EKE 60.2M

Replacing the touch control - spare-part no. 564525, old with spare-part number 531809

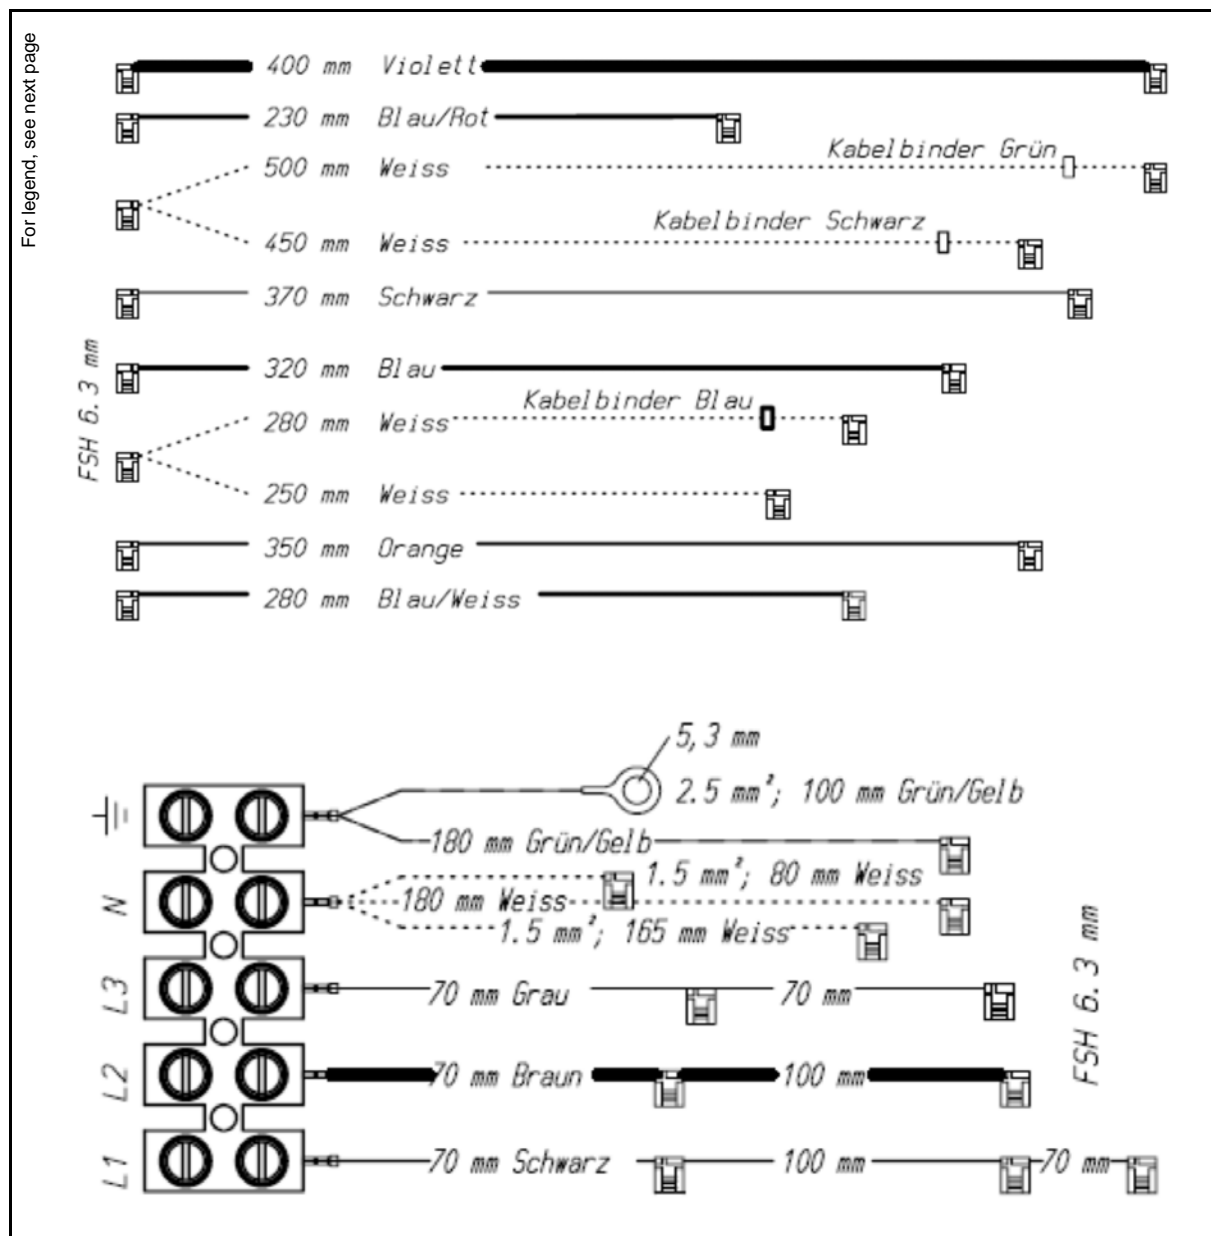
Contacts 30 and 31 of the touch control (spare-part no. 531809) have been modified and the cable connections are now too short. The cable harness enclosed must also be installed as a replacement. Once the repair has been carried out a VDE 0701 test must be carried out.
